**Attachment 2 to PLA-6138**

**Non-Proprietary Version  
of the PPL Responses**

### **Acceptance Comment 1**

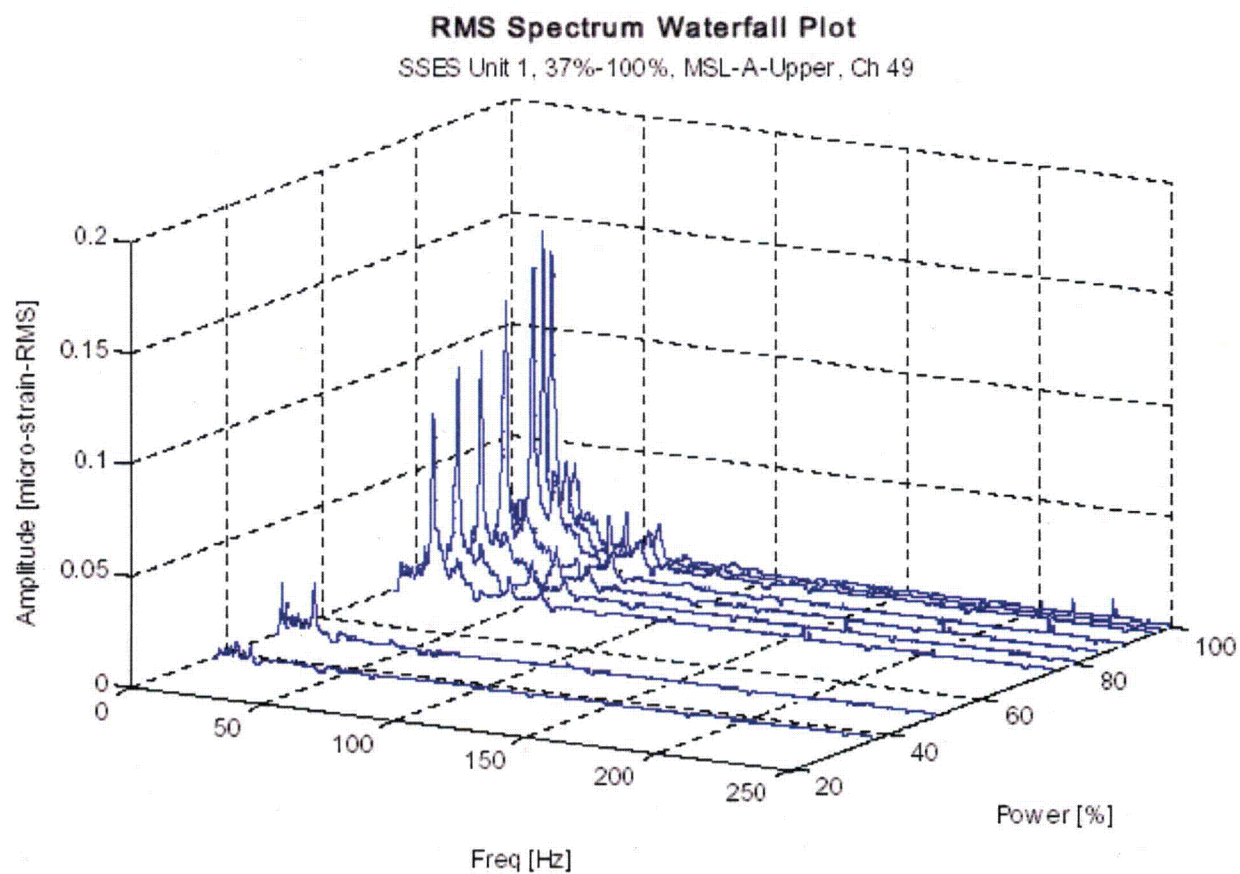
The licensee's submittal indicates the presence of a strong spectral peak at about 110 Hz in the SSES 1 and 2 plant measurements on the steam dryer. The licensee should discuss the source of this peak and the absence of its prediction in the analysis.

The frequency of the observed panel resonance matches the recirculation pump vane passing frequency corresponding to the core flows and recirculation pump speeds present when the measurements were made. The 110 Hz peak observed in the second bank hood panel strain gauge measurements is due to a local structural resonance in the panel where strain gauges S4 and S5 were located. The dryer panels are responding to a strong vibration response in the recirculation loop piping that is excited by the recirculation pump vane passing frequency. The piping vibration is transmitted through the vessel to the dryer supports. This recirculation piping vibration response was first observed in SSES Unit 2 when the plant entered the Increased Core Flow (ICF) region for the first time following licensing of the ICF region.

The recirculation pump vane passing frequency matched a structural mode of the panel at the core flow conditions when the measurements were taken (110 Hz at 100% OLTP and 113 Hz at 90% OLTP). The 110 Hz response was noted at that time of the measurements, as determined in MDE-199-0985-P, Revision 1, which is provided as Appendix 1 of this letter. At that time, the source of the resonance was not investigated. Structural analyses in MDE-199-0985-P, Revision 1 determined that the 110 Hz frequency was a structural mode of the second panel. These conclusions were confirmed by performing a vibration analysis using the current whole dryer finite element model. The fatigue evaluation presented in Attachment 10 considered flow-induced vibration resulting from pressure loads applied directly to the dryer. Because the 110 Hz vibration load was transmitted mechanically through the dryer supports, it was not predicted in the pressure load Flow Induced Vibration (FIV) analysis presented in Attachment 10 of PPL's CPPU submittal.

Figures 2 and 3 show the frequency spectra for the second bank strain gauges for power levels from 70% to 100% OLTP. In Attachment 10, a scaling factor was developed in order to adjust the predicted stress results from the finite element analysis to be equivalent to the stresses indicated by the in-plant dryer instrumentation. The scaling factor was based on a comparison of the predicted strains to the measured strains for S4 and S5 at the 100% OLTP power case where the 110 Hz peak is the highest. As discussed above, the 110 Hz peak shown in Figures 2 and 3 were correlated to the recirculation pump vane passing frequency. Because this dominant peak is based on the

recirculation pump vane passing frequency and a local structural resonance, a stress under prediction factor based on it will be bounding for the other power levels. Without the 110 Hz peak, the stress under prediction factor would be approximately 30% lower. The rest of the frequency spectrum is proportional to steam flow during the power ascension. The pressure loads, as shown by the pressure drum (Figure 4) and steam line pressure measurements (Figure 5) are also proportional to steam flow as power increases. If the 110 Hz peak were not present, a scaling factor based on the measured strain gauge response would be relatively constant as power increased. Strain gauges S4 and S5 were located on the second bank panel near the high stress location where the weld seam cracked during the first cycle. It is most likely that the 110 Hz peak is a local structural resonance in this panel caused by the vibrations introduced by the recirculation pump vane passing frequency. The structural performance of the dryer over more than 20 years suggests that there are no other locations on the dryer that are experiencing high stresses as a result of the recirculation pump vane passing vibration.
